## MEMO

**FROM:** Eric Engstrom, Bureau of Planning and Sustainability, Principal Planner

**SUBJECT:** 2035 Comprehensive Plan Early Implementation  
Minor/Technical Amendments

**Figure 130-9**  
**Façade Articulation**

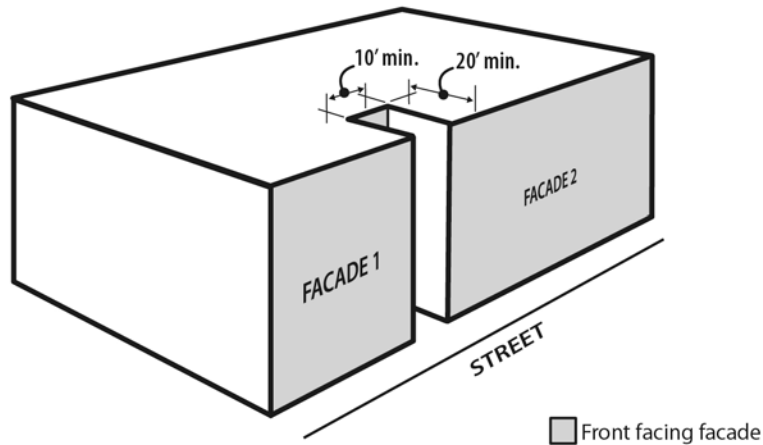
Amendment #2m: Add a new drawing (Figure 130-9) to better illustrate the façade articulation standards in 33.130.222 (pg. 153). Renumber the existing 130-9 through 130-17 to be 130-10 through 130-18.

**Figure 130-11**  
**Ground Floor Window Options for Dwelling Units**

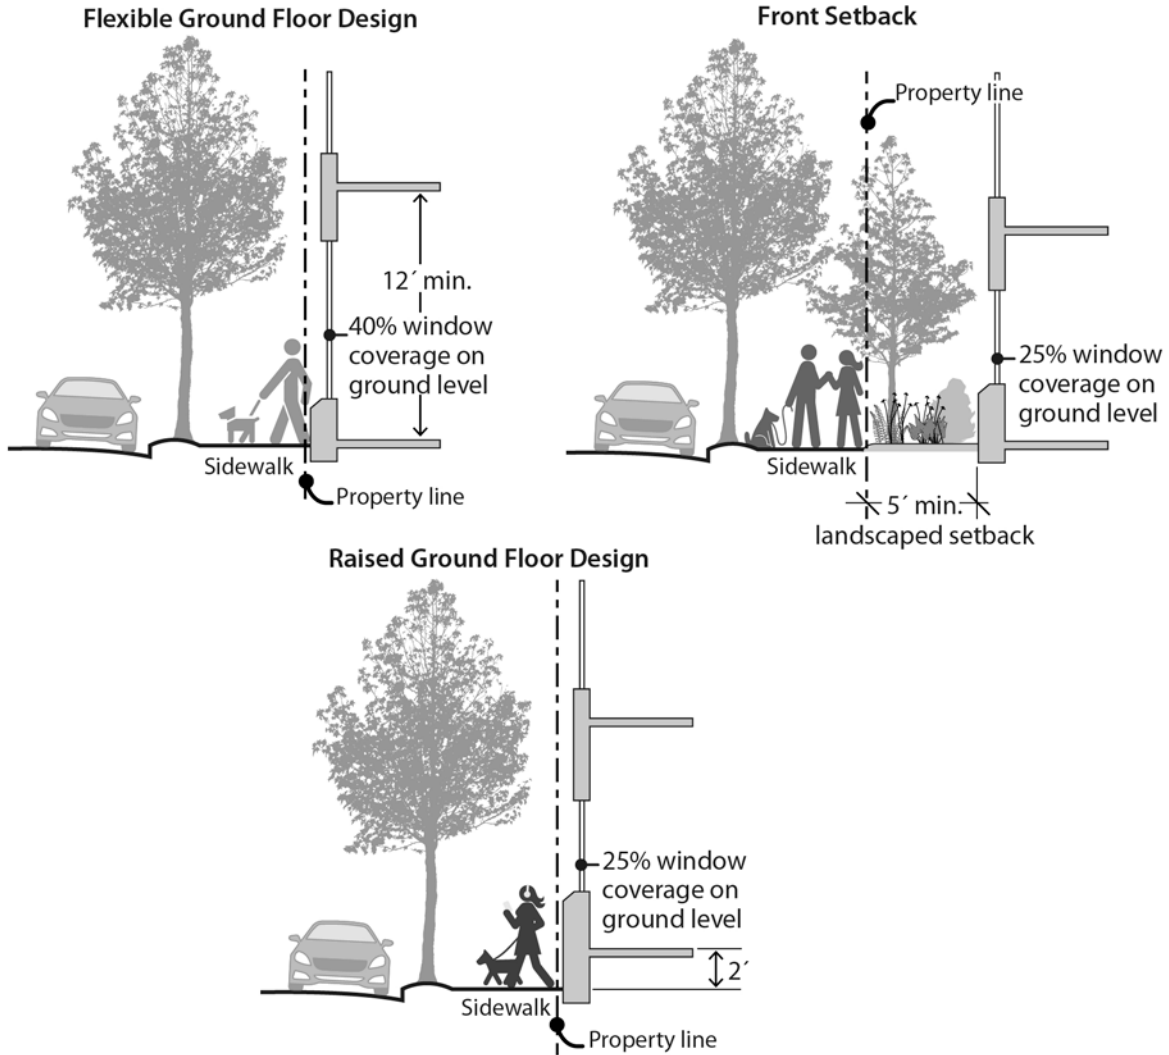
Amendment #2o: Fix figure 130-11(pg. 165) to show the property line in the right place
